Building Permit Application
City of Portland, Oregon - Bureau of Development Services

Description of work	
A MIXED-USE 4 STORY BUILDING WITH RETAIL ON THE GROUND FLOOR AND APARTMENTS ABOVE.

Life Safety Checksheet Response

LIFE SAFETY CHECKSHEET

The following two Figures show the amendment: Figure 1 shows the assembly that was reported in the Jun 9, 2011 report, and Figure 2 is the amended Assembly. We tested the floor directly on the concrete.

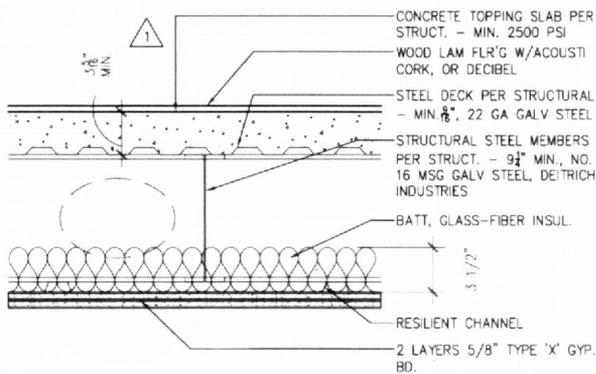
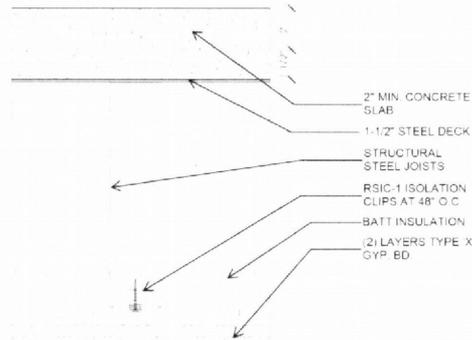
On November 4, 2011, Mr. Ron Huffman from *Lorentz Bruun Co., Inc.* informed *AACOUSTICS* that the floor/ceiling assembly shown on Page #3 of the said report is an error. Please note that all other information's in that report were correct and are not changed.

Figure 2 is the corrected assembly

F3 FLOOR/CEILING, 1-HR RATED
 ICBO: UL: 0551 STC: 62 FIIC: 47 1HR. RATED
